### Addendum No. 1

#### Cobbs Creek Playground (700 Cobbs Creek Parkway)

#### Philadelphia Redevelopment Authority

Issue Date: August 18, 2022

**MATERIALS, FURNISHING & EQUIPMENT PLAN**

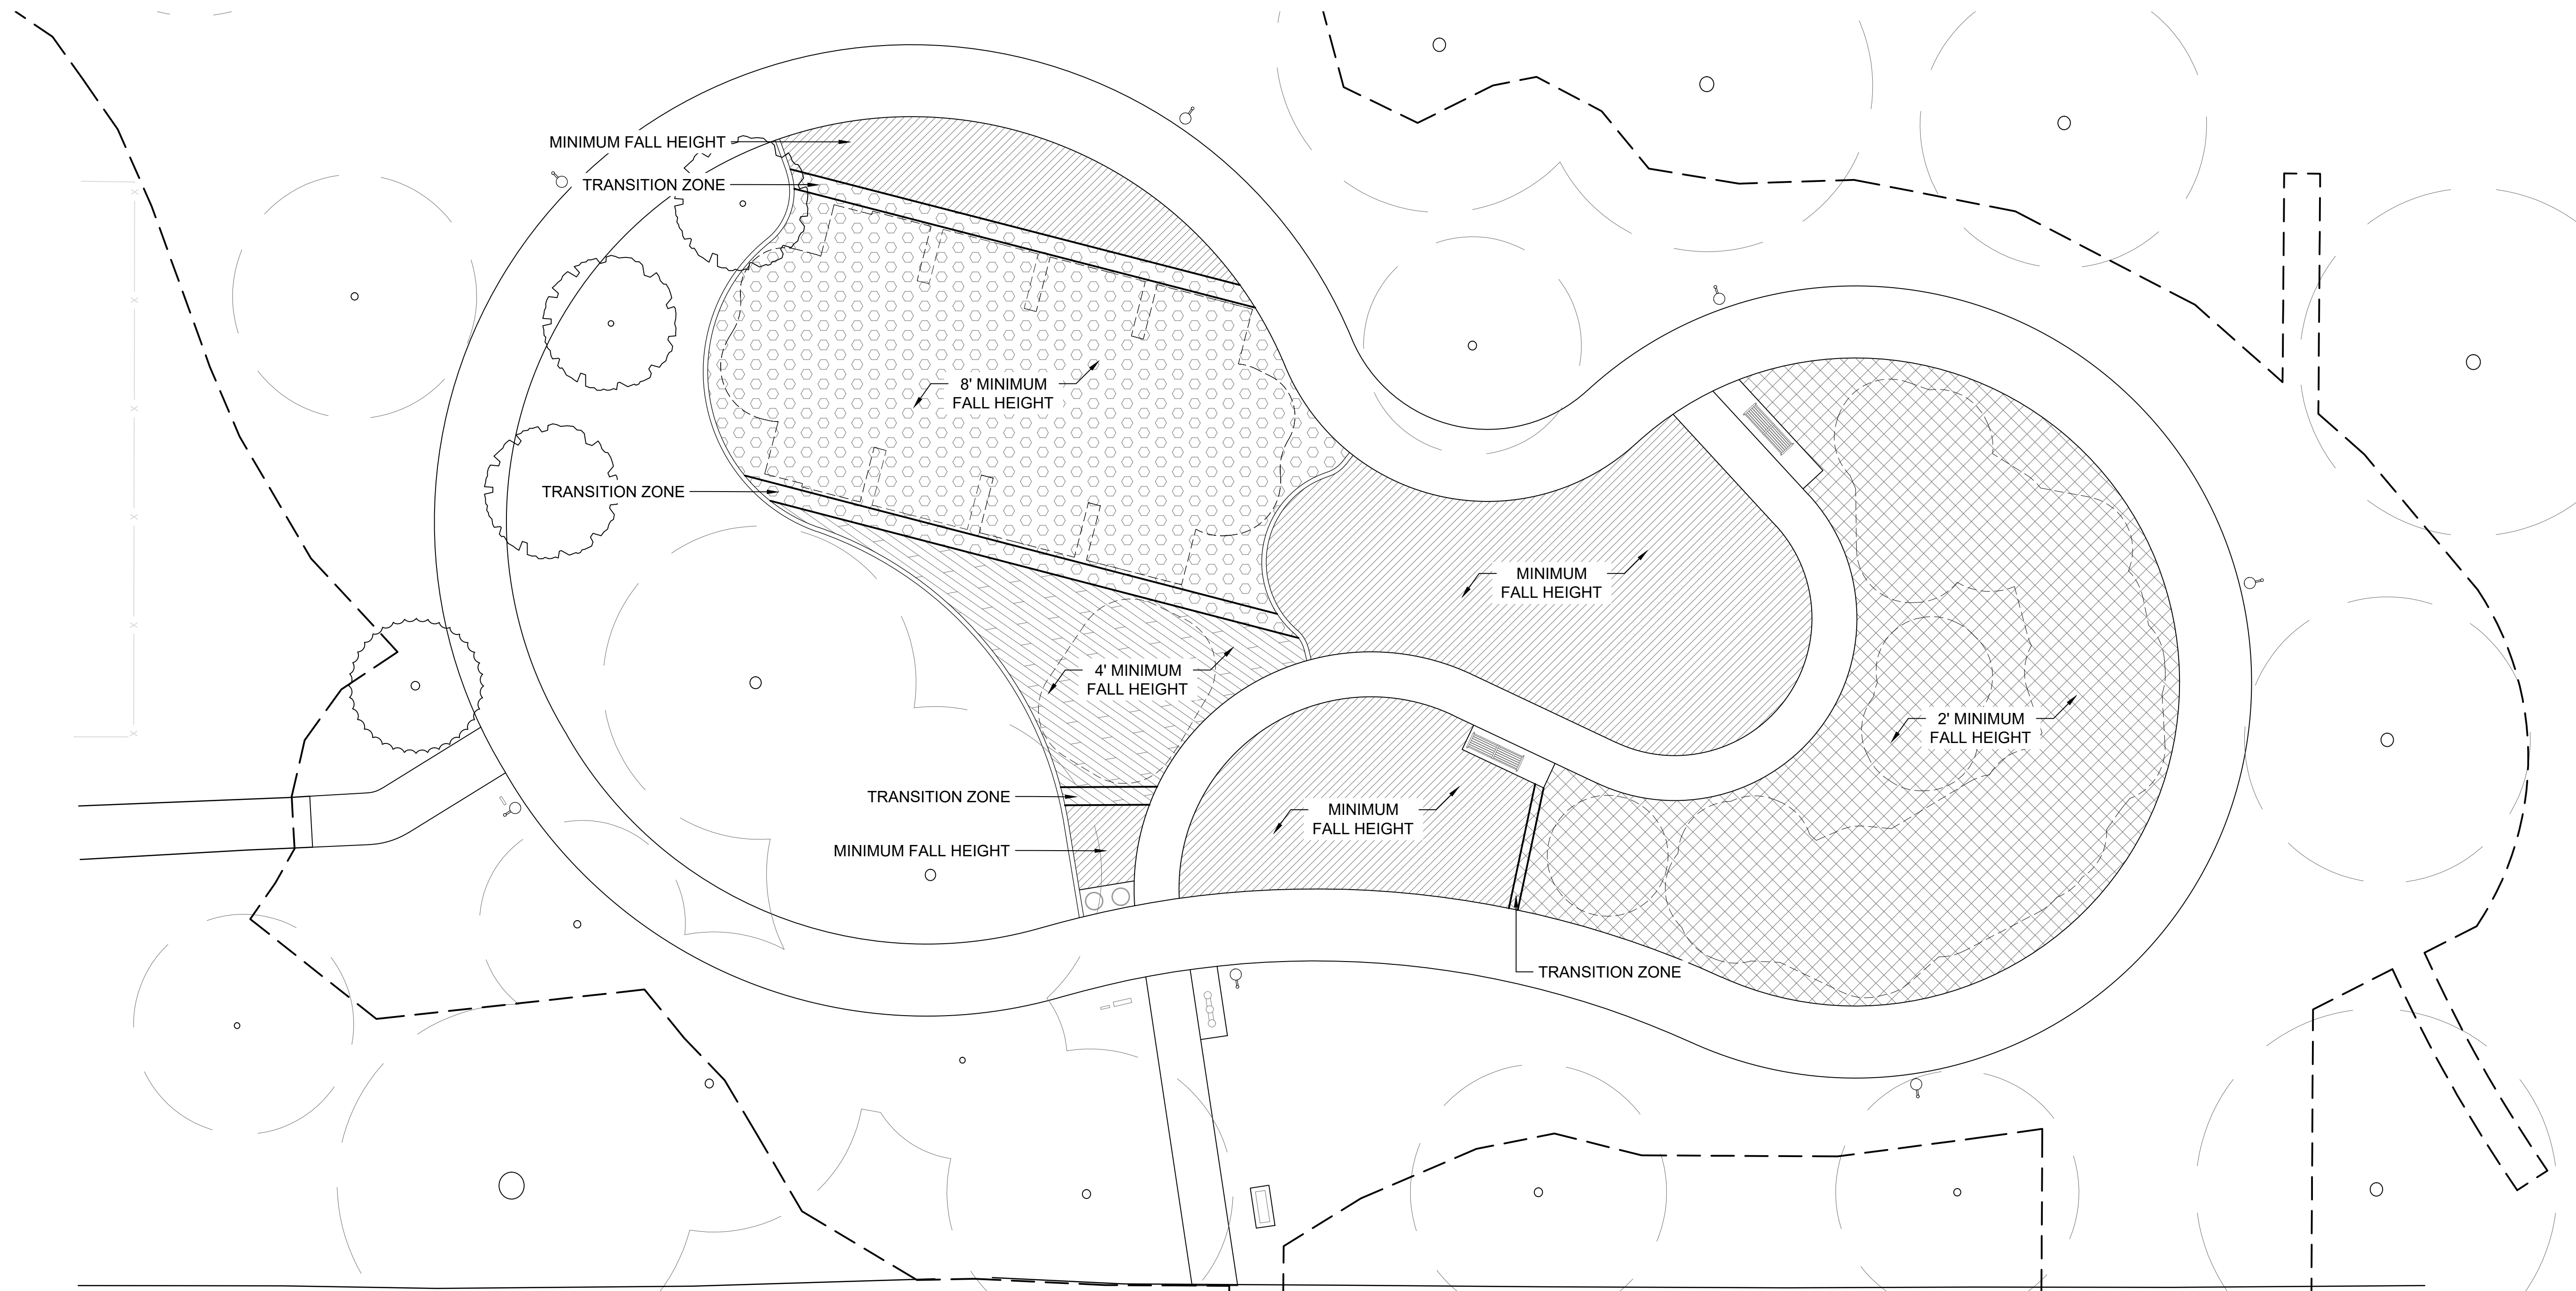
- b. L-101 Overall Site Plan
    - i. Added site plan note 6.
  - c. L-102 Materials, Furnishings & Equipment Plan
    - i. Added limit of work plan.
  - d. L-103 Layout Plan

5 SAFETY SURFACE MOUND  
 SCALE: 1" = 1'-0"

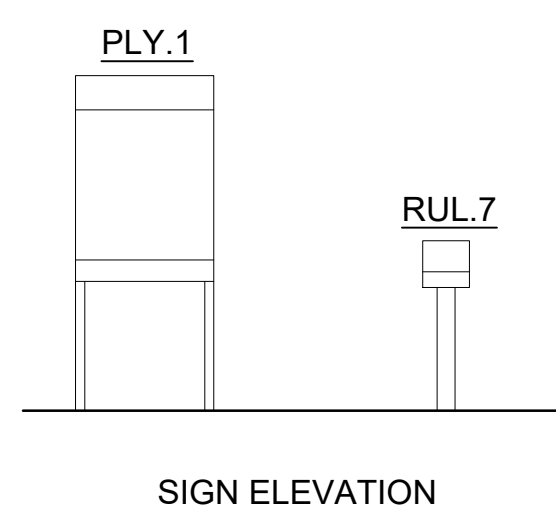
- g. L-201 Site Details
    - i. Detail 5 – removed note for geotextile.
  - h. L-203 Deduct Alt 2: Site Details
    - i. Revised detail 1 where poured-in-place surface meets concrete curb.

Response: No dog waste dispensers are specified for this project.
5. The safety surface details on Sheet L-200 do not shown geotextile fabric under the safety surface. The mound detail on Sheet L-201 does show fabric. Is fabric required under the safety surfaces?

Response: No geotextile is needed at any safety surface location. Detail 5/L-201 will be updated in addendum to remove geotextile.
6. Regarding Keyed Note #9 on Sheet E-100, please provide a distance to the existing pull box that all bidders are to include in their price.

DRAWING NO:  
**L-300**  
SHEET 13 OF 22

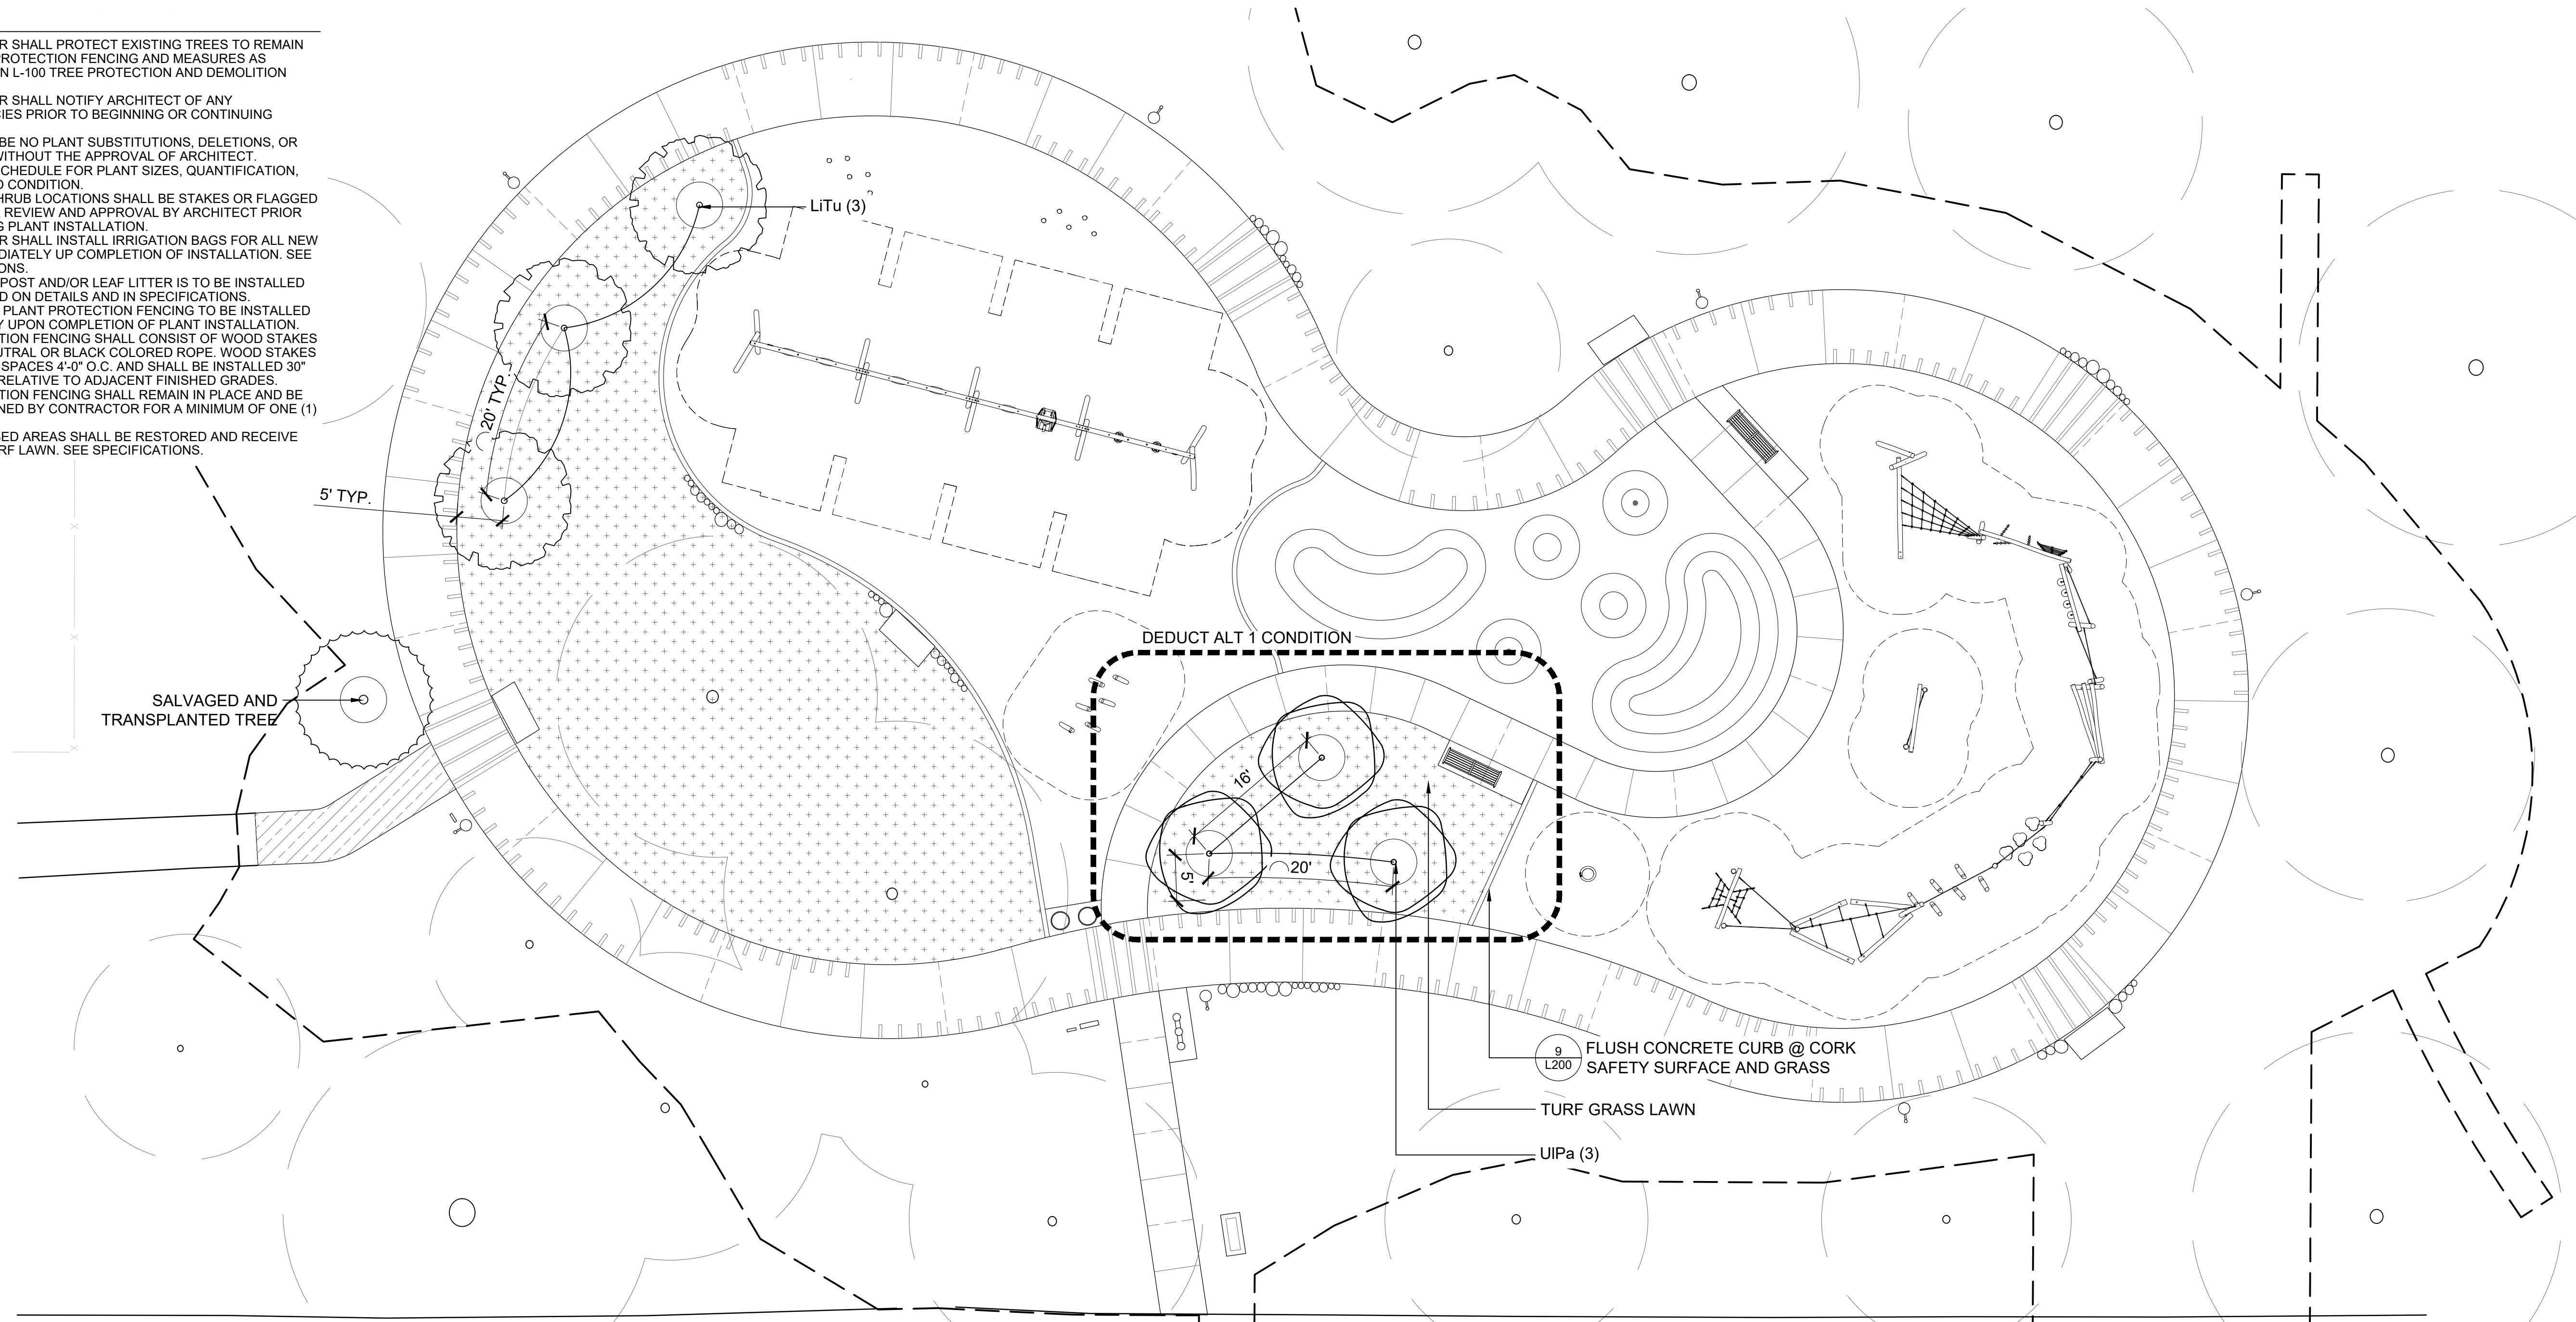
- i. L-300 Planting Plan and Details
    - i. Added limit of work line.
  - j. C-100 Grading and Utility Plan
    - i. Added LOD and electrical lines.
  - k. C-200 Erosion Control Plan

DRAWING NO:  
**C-200**  
 SHEET 15 OF 22

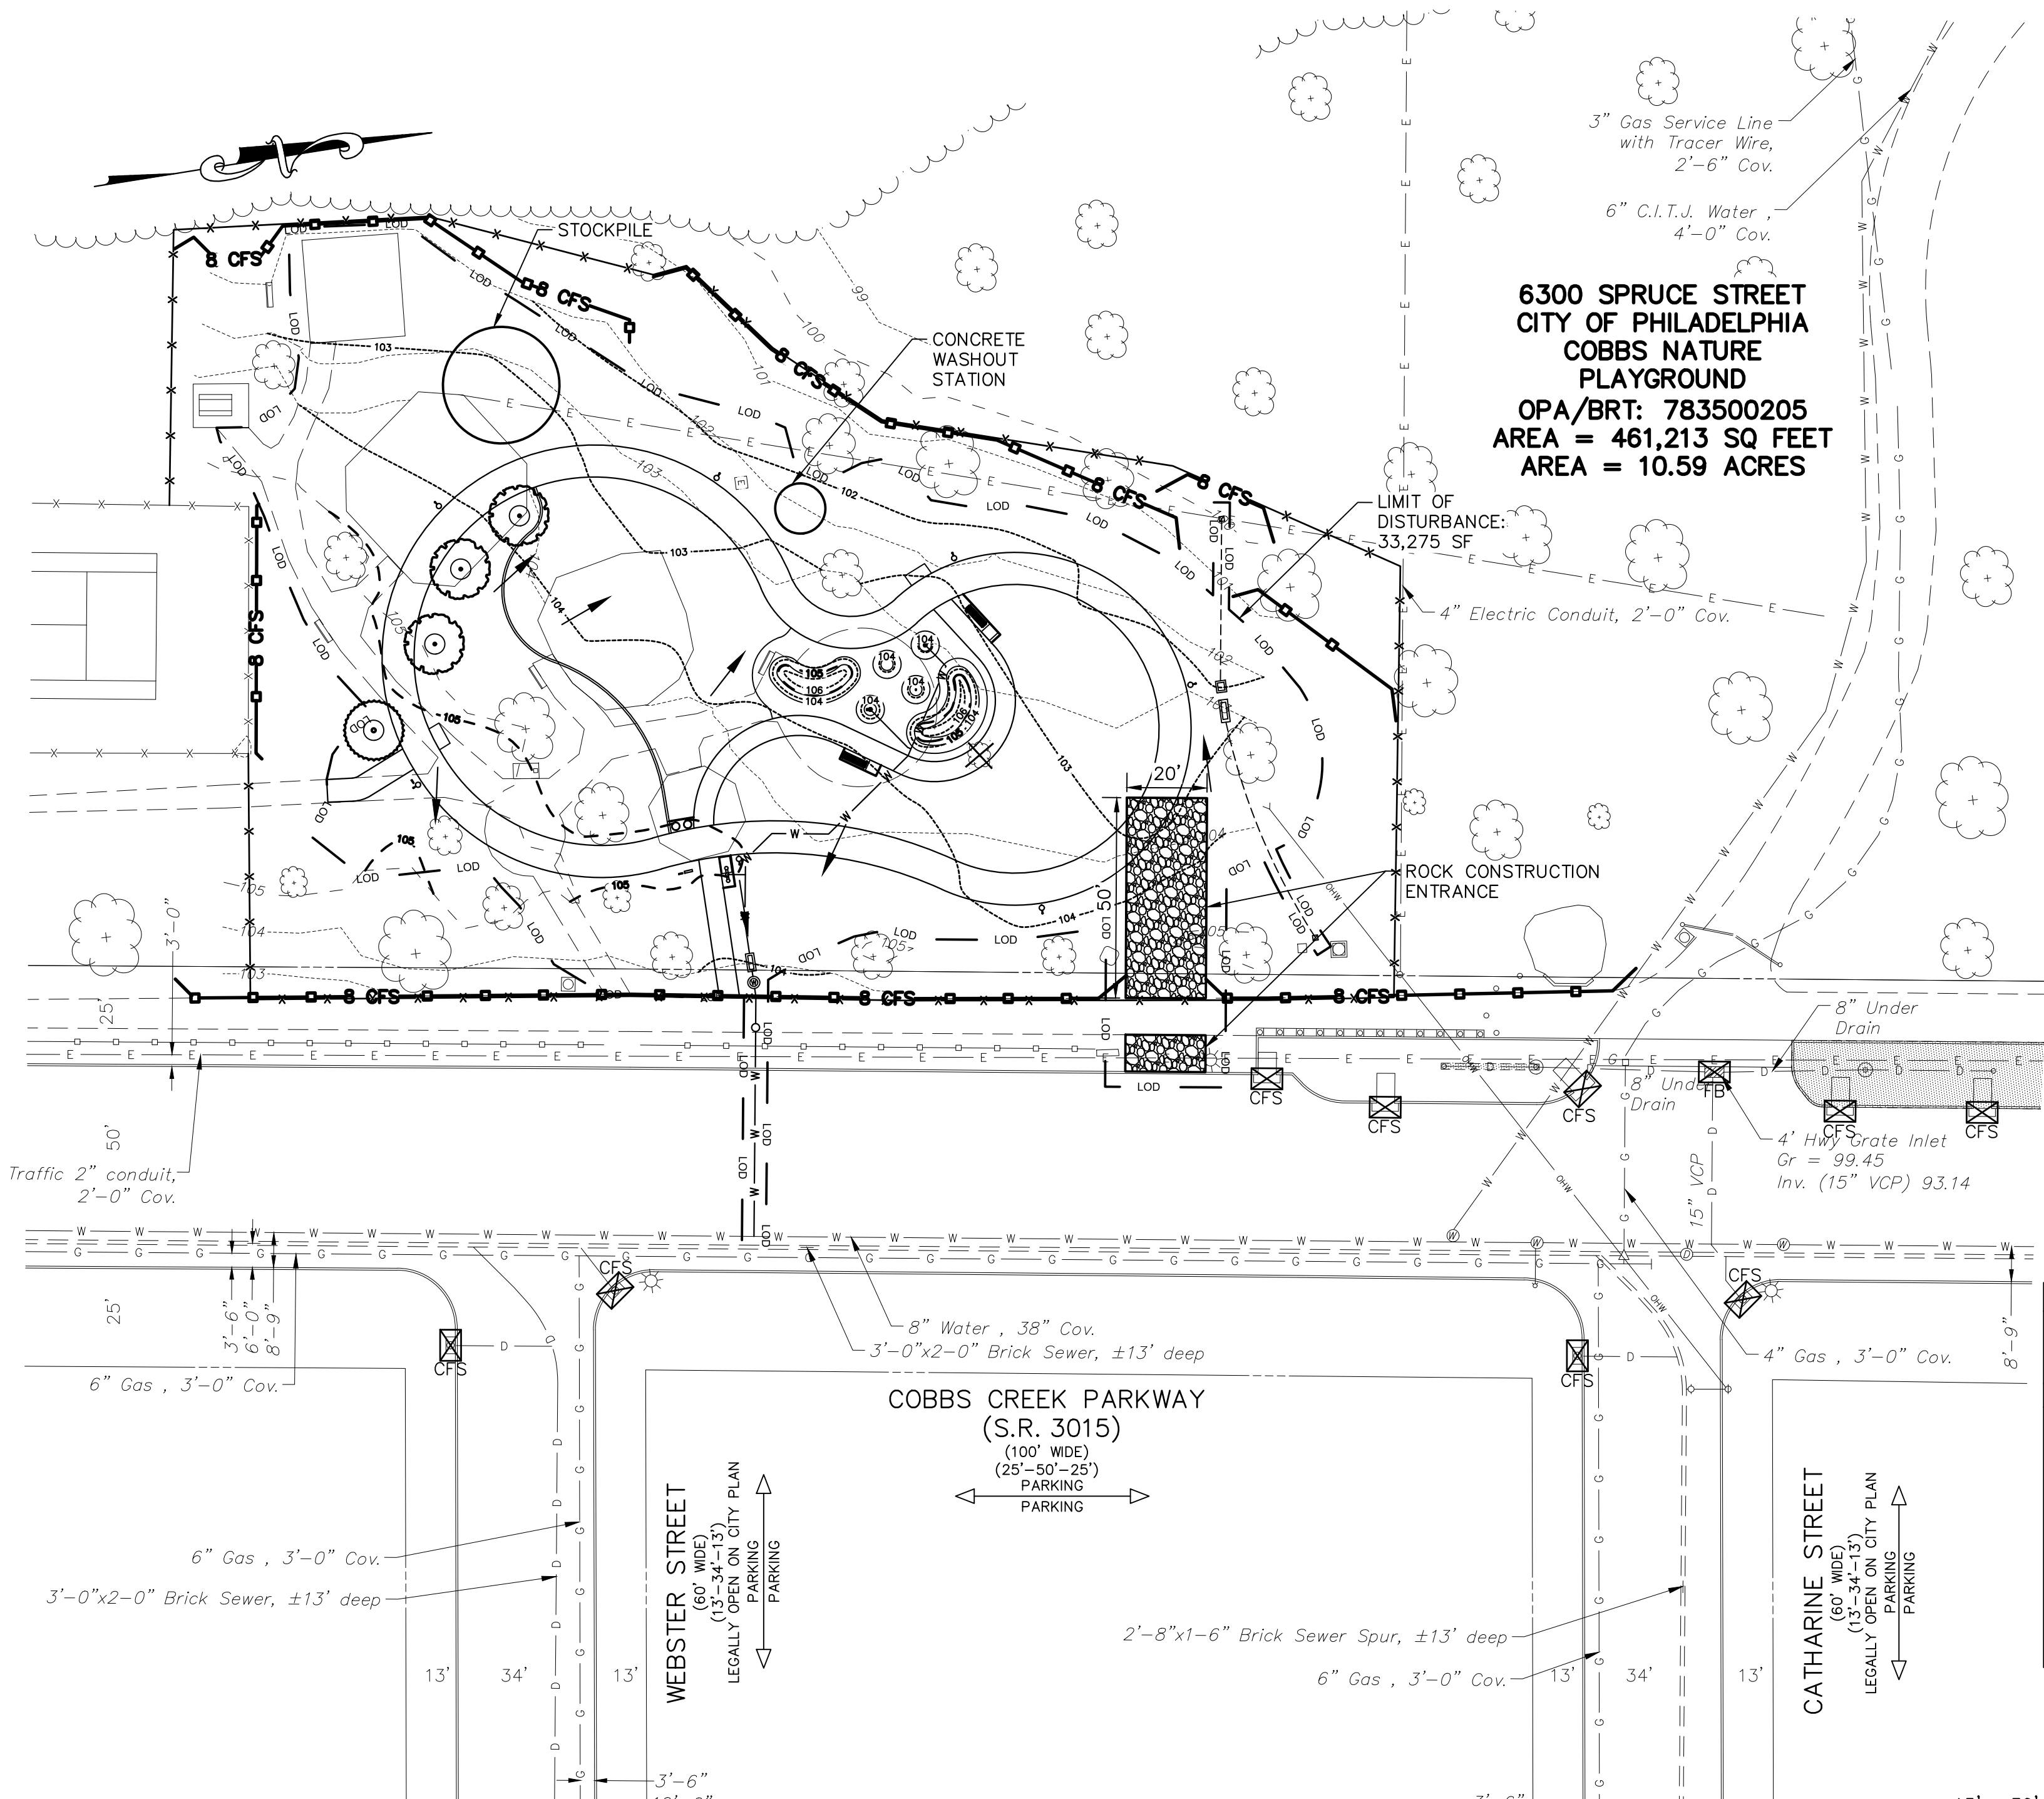
- i. Added electrical lines.
    - ii. Revised LOD and construction entrance.
